# Access Compliance Report

## Public Rights-of-Way

### (Curb Ramps)

Intersection ID: 19463	Main Street: BARCLAY_DOWNS_DR	Cross Street: SAYRE_RD	Location: S
ADA ID: 4164B6DE9B15	Ramp Type: Perp	Initial Pass/Fail: Fail	Overall Compliance: No
Severity Score: 10			
Codes/Mitigation Info/Possible Solution		Field Measurements/Component Compliance

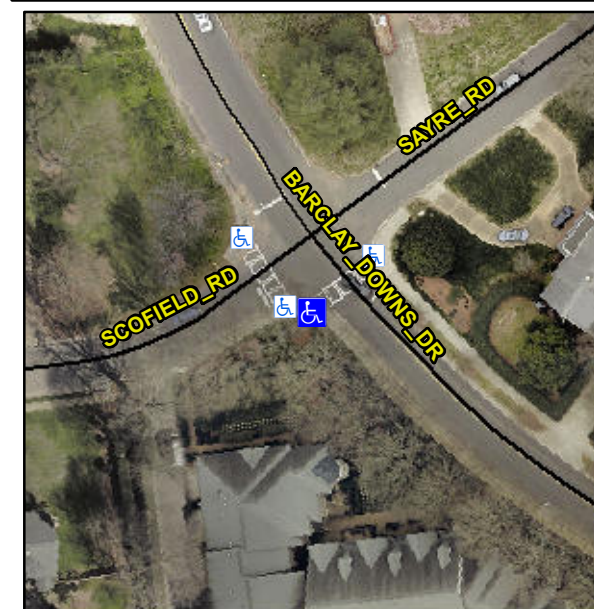
**R304.5.1, R304.5.3**

Compliance	Description	Data	Compliance	Description	Data
N/A	Ramp Length (in)	72.0	Yes	Ramp Slope (%)	5.1
No	Ramp Width (in)	41.0	No	Ramp XSlope (%)	2.1
N/A	Flare Type LT	N/A	N/A	Flare Type RT	N/A
N/A	Flare Slope LT (%)	N/A	N/A	Flare Slope RT (%)	N/A
N/A	Flare Traversable LT?	N/A	N/A	Flare Traversable RT?	N/A
N/A	Landing Length (in)	N/A	N/A	DWS Provided?	N/A
N/A	Landing Width (in)	N/A	N/A	DWS Contrast?	N/A
N/A	Landing Slope (%)	N/A	N/A	DWS Length (in)	N/A
N/A	Landing X Slope (%)	N/A	N/A	DWS Full Width?	N/A
N/A	Landing Curb? (Y/N)	N/A	N/A	DWS Offset (in)	N/A
N/A	Shared Landing?	N/A			
N/A	Gutter Ponding?	N/A	N/A	Gutter Slope (%)	N/A
N/A	Gutter Lip Ht (in)	N/A	N/A	Gutter X Slope (%)	N/A
N/A	Painted X Walk1?	Yes	N/A	Painted X Walk2?	N/A
	X Walk 1 Direction	To E		X Walk 2 Direction	N/A
N/A	X Walk 1 Width (in)	97.0	N/A	X Walk 2 Width (in)	N/A
	X Walk 1 Slope (%)	2.1		X Walk 2 Slope (%)	N/A
	X Walk 1 X Slope (%)	0.8		X Walk 2 X Slope (%)	N/A

**Remove & Replace Entire Ramp.**
